SUBJECT: MEETING NOTICE AND TRANSMITTAL OF TENTATIVE AGENDA

5. Salt River Pima-Maricopa Indian Community Consultant Report Regarding the Draft Small Plant Review and Approval for the Preserve at Goldfield Ranch Water Reclamation Facility

SRP-MIC
Goldfield Ranch Small Plant Review Technical Support

Figure 1: Potential overland flow path from WRF to Verde River

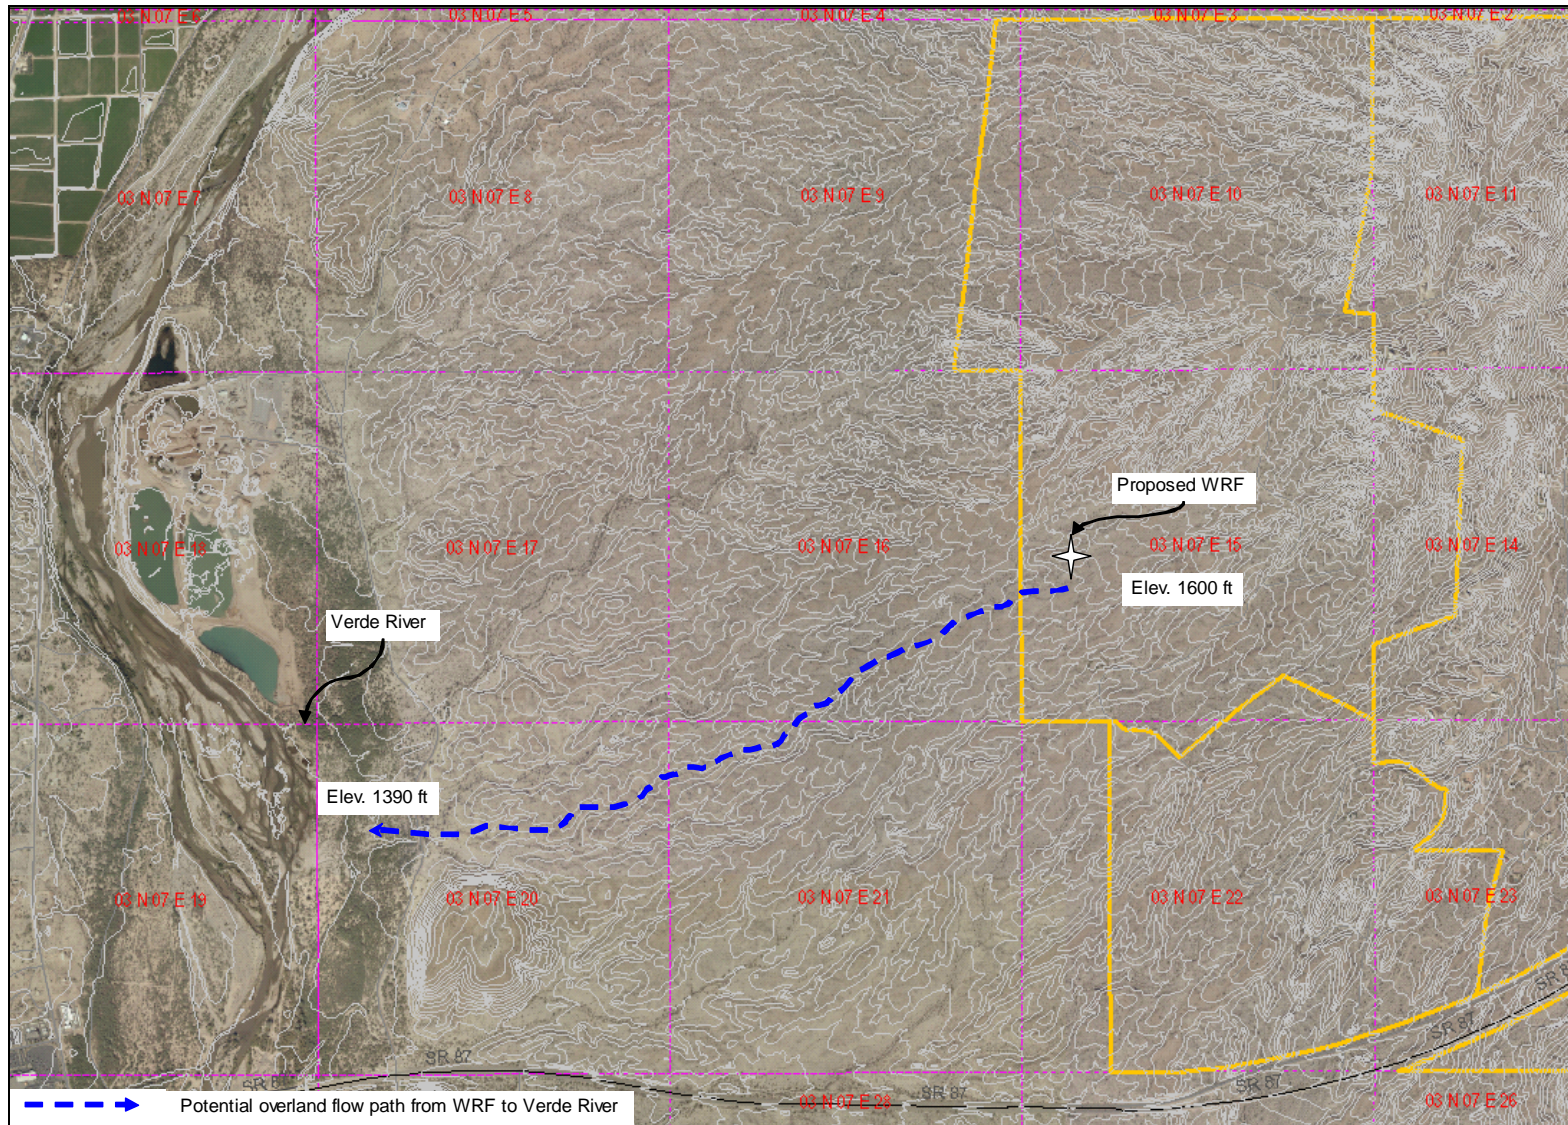
The unique features of the proposed plant's location relative to the Verde River, the surrounding topography, and the increased risk it poses to surface water quality standards established for the protection of wildlife and humans have not been adequately considered. While the proposed plant will have redundant power supply and on-site retention, a service failure of it or of the associated sewage lift stations throughout the community (which are not proposed to have redundant power or retention) would result in a sewage overflow that could make its way to the Verde River. The proposed plant location is 2.5 miles and 210 feet in elevation from the Verde River. At build-out capacity, unimpeded wastewater overflows from the proposed plant could reach the river within 6 to 18 hours of plant failure.

Fourth, it is enveloped by sensitive habitat, a Native American community, and the Tonto National Forest, and will likely never be included in an MPA within the county. In comparison to the Small Plants identified in Section 3, the responsibility for this plant will initially and likely always be a CID. Based on the factors identified above, the plant and associated sewage collection facilities may require sophisticated technology, operation, and attentive control, and should be sized to manage the wastewater from the entire area of private and developable land. Additionally, operation, maintenance, and replacement costs will be significantly higher per service connection than the typical wastewater system, which may be difficult for a CID to continuously fund.

MAG Question:
Do certain areas lend
themselves to being included
in service area?

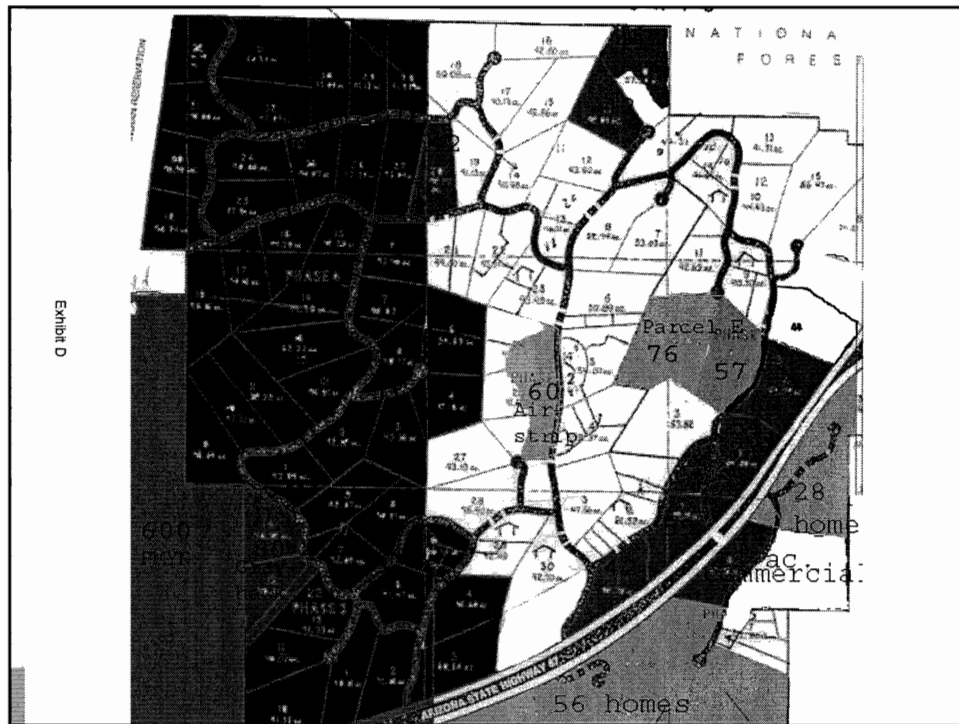
Evasive Answer:

Small parcels to the east,
already with septic
tanks, probably not (¶3.2.2)

What was not answered?

- What about small parcels without septic tanks?
- What about large parcels?
- What about land to the west?
- What about land outside of Goldfield Ranch?

Question: Can this plant be expanded?

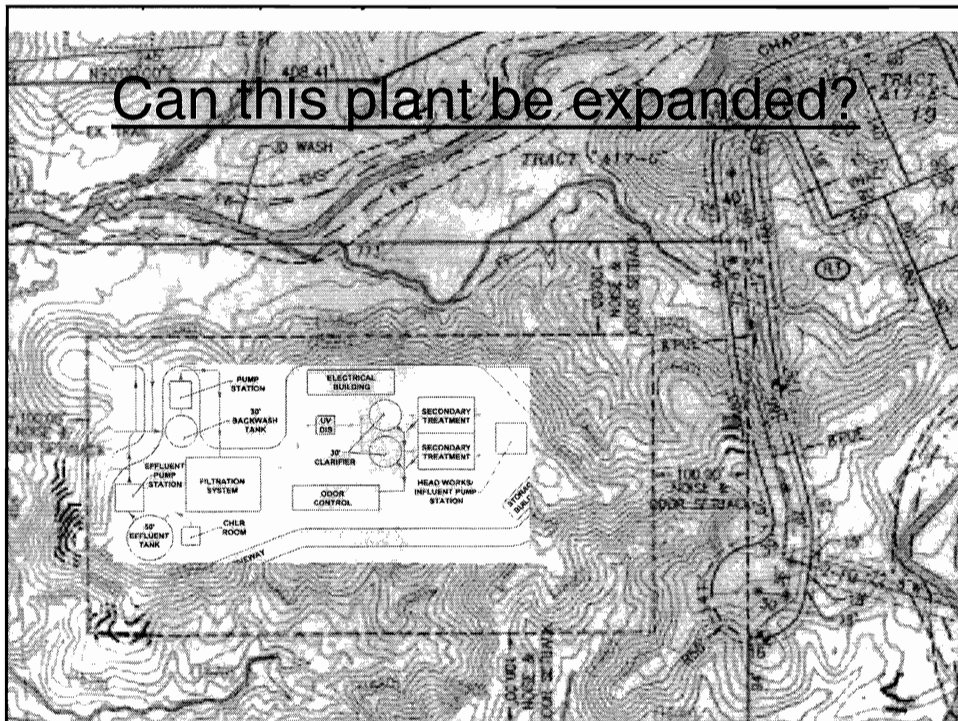
- Evasive Answer: The relatively small parcels of private land on the east will not likely exceed plant capacity (¶ 3.2)

What was not answered?

- Can this plant be expanded?
 - Yes or no?
 - An engineering question, not a lawyer question
- What about?
 - Large parcels
 - Parcels to the West, *e.g.*, Grayhawk
 - Ellman's other parcels
 - Commercial development
 - 18 ac. between C and D – 1995 DMP still in effect
 - 50 acres on FMYN land

Tribal Comment and Response

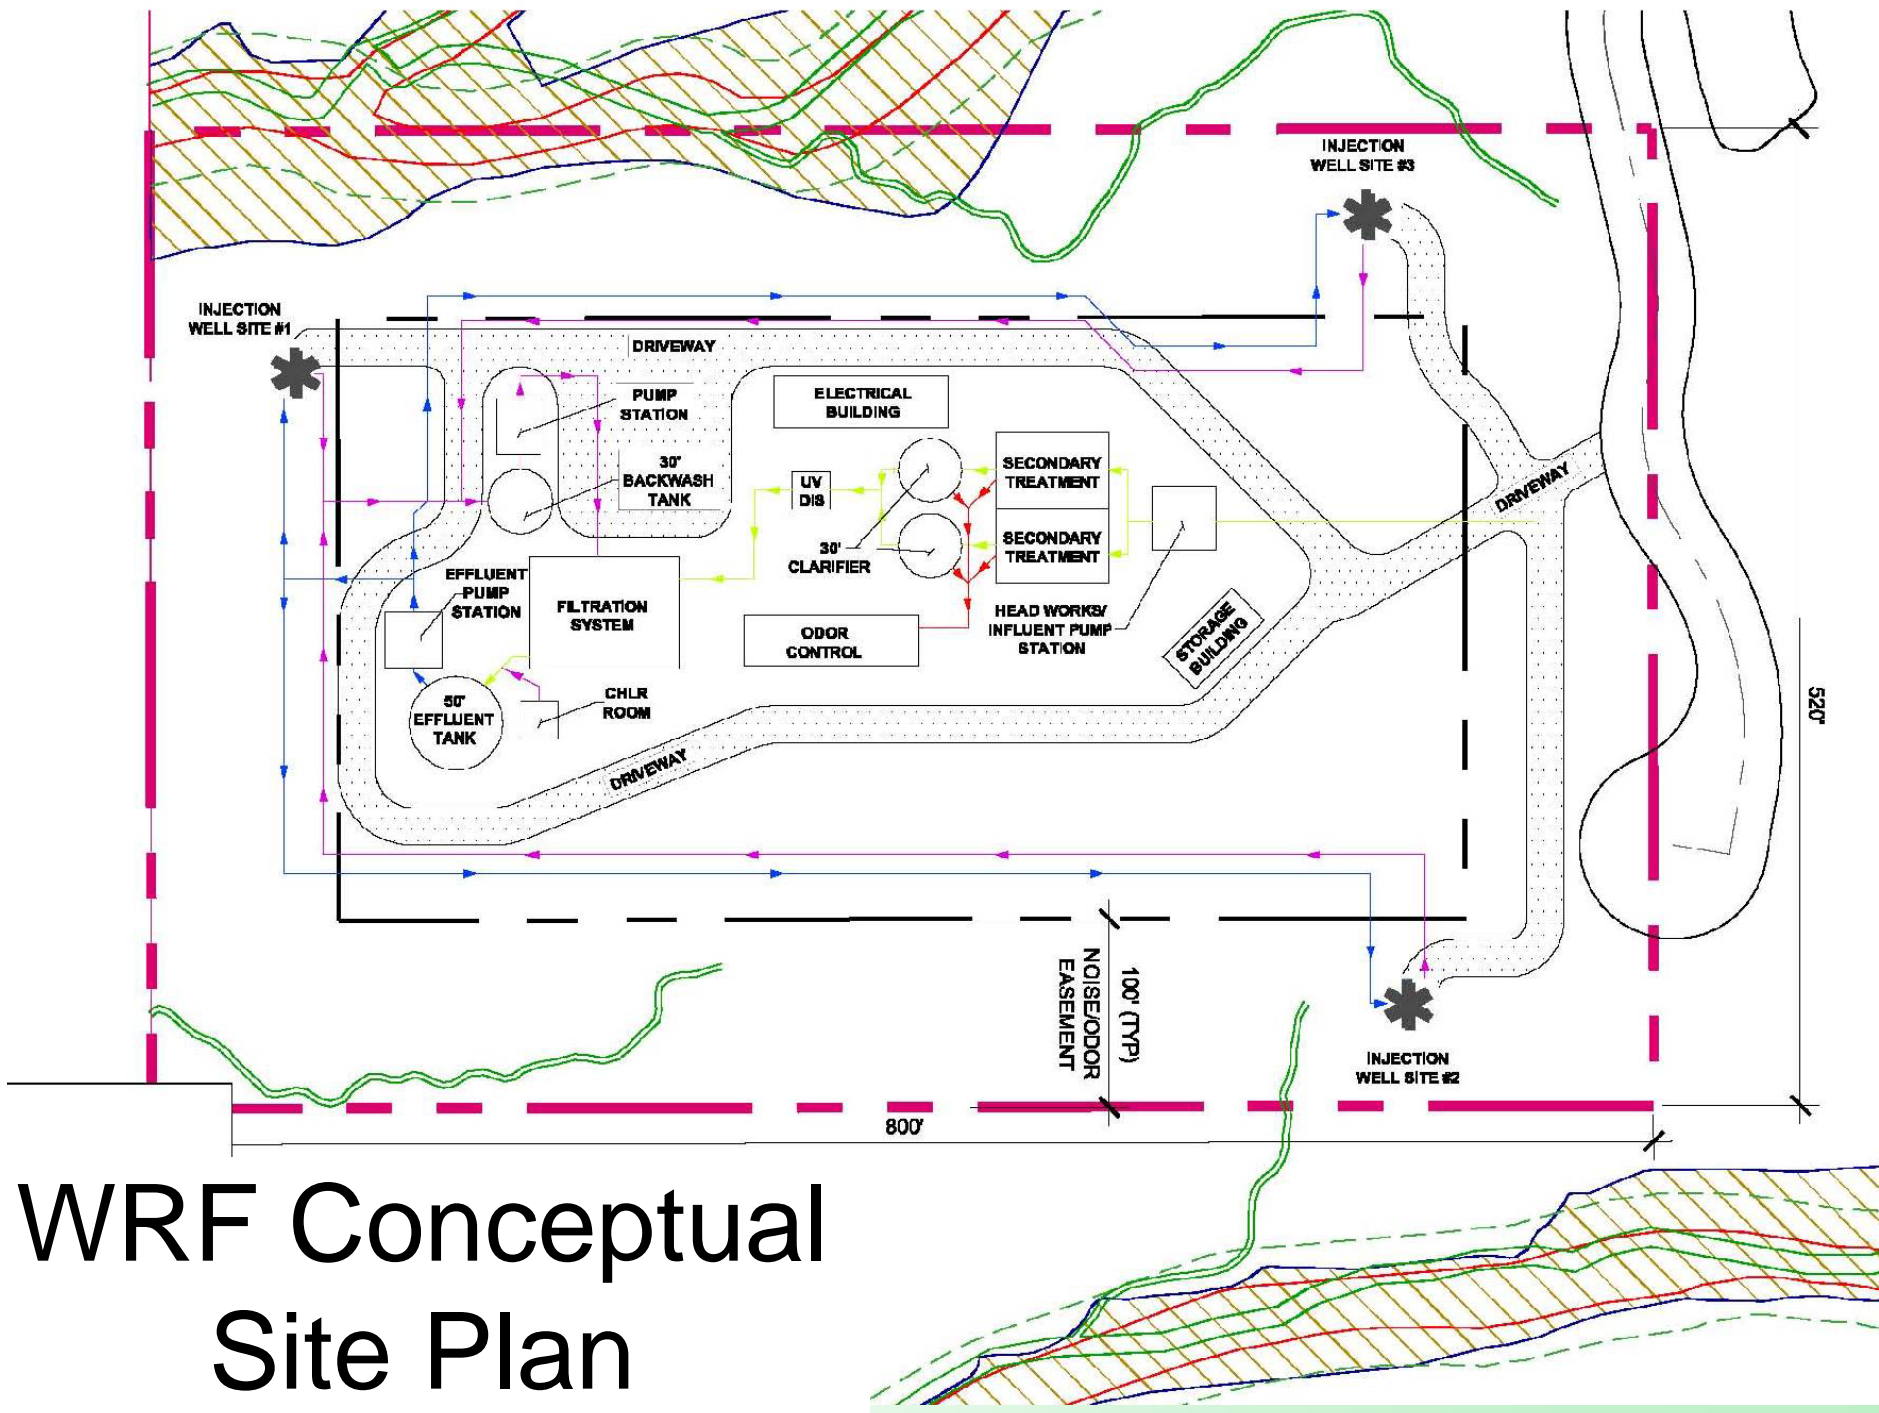
- Comment: Provide details of proposed treatment and effluent disposal
- Response:
 - Effluent quality and design requirements are the same for every wastewater treatment plant across the state
 - Regulated by ADEQ, ADWR and MCESD
 - Public process for APP and USF permitting

Tribal Comment and Response

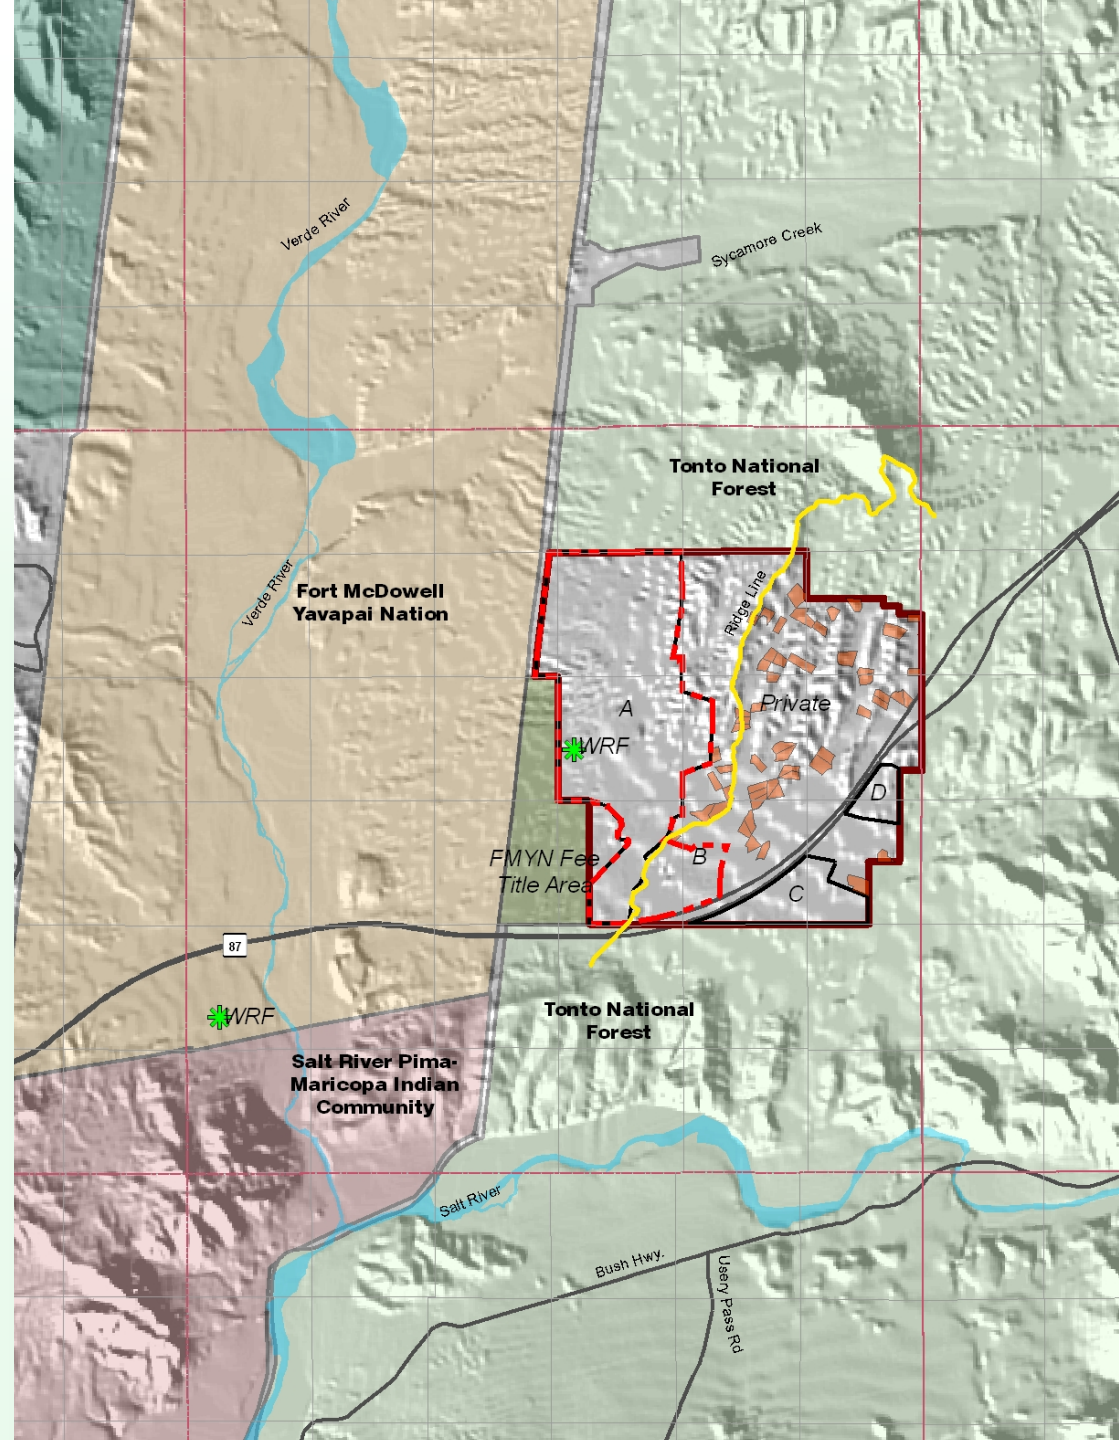
- Comment: Provide for proposed commercial customers
- Response:
 - Wastewater flow from potential restaurant less than 1 or 2 percent of total flow to WRF
 - Grease trap anticipated as part of WRF design
 - Grease trap anticipated at restaurant
 - Wastewater flow from potential resort/spa including restaurant 13 percent of total flow to WRF
 - Removal of detergents part of facility design
 - Anticipated influent water quality consistent with MCESD comments due to low flow fixtures

Tribal Comment and Response

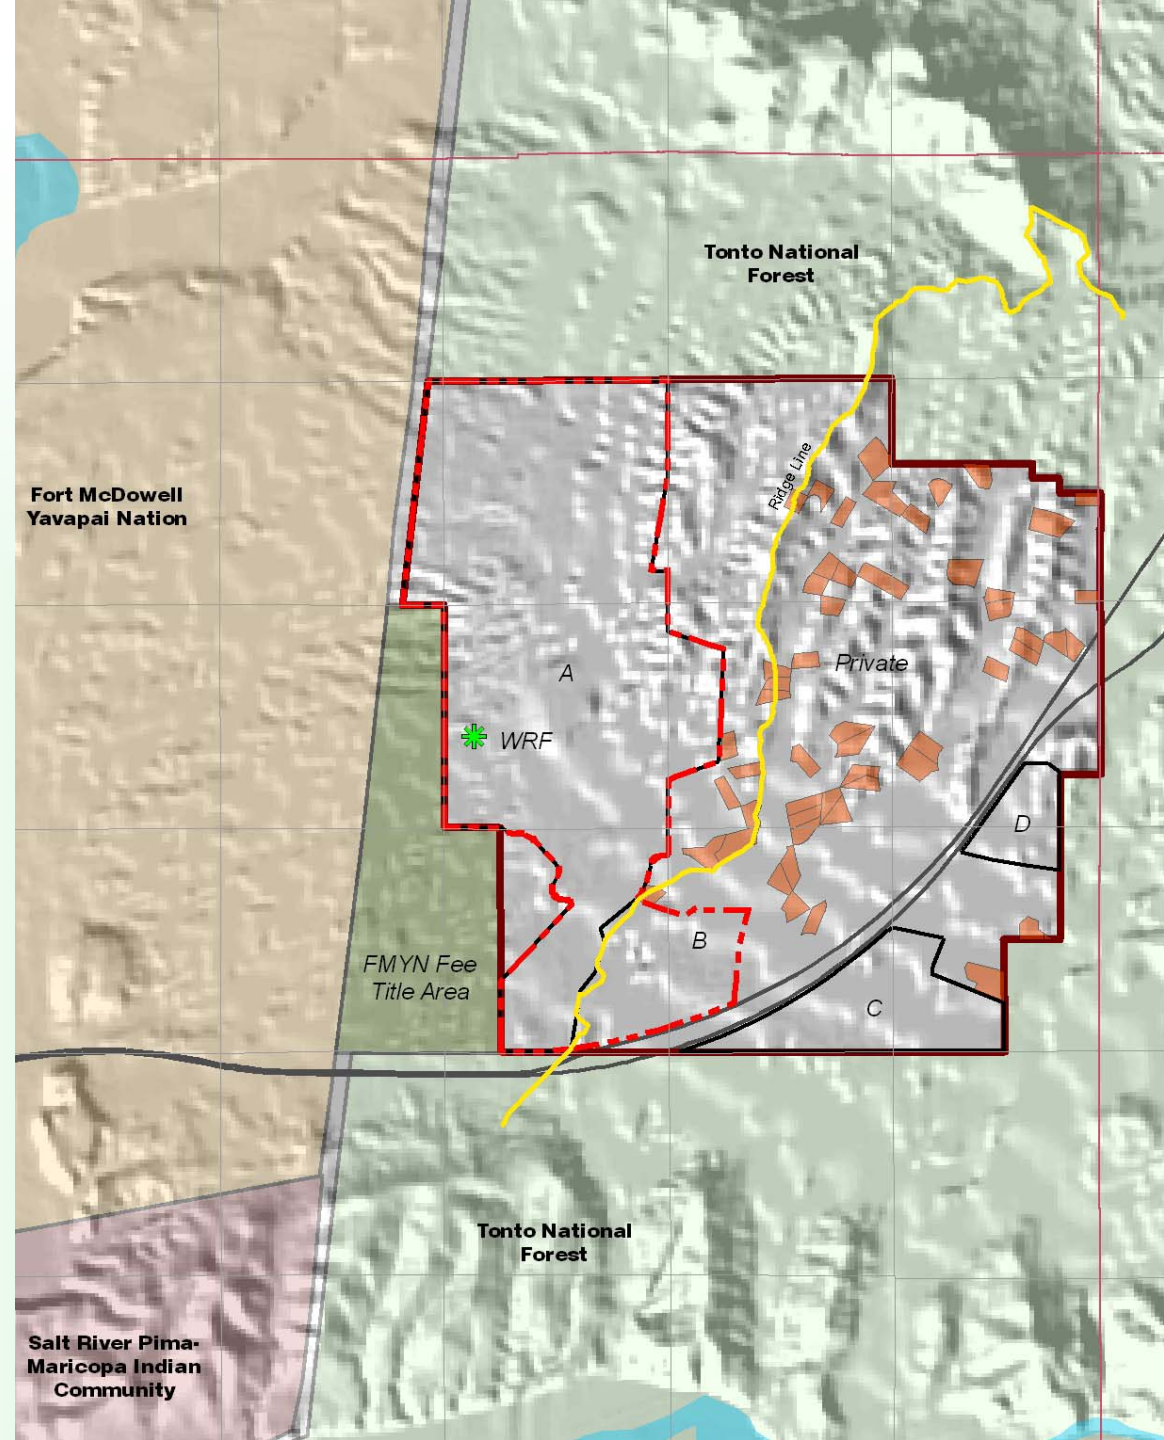
- Comment: Desert nesting bald eagle may be impacted by micro-pharmaceuticals and other by-products in the Verde River
- Response:
 - Issue does not pertain to the 208 Application
 - No discharge to the Verde River
 - WRF will comply with all applicable regulations and standards
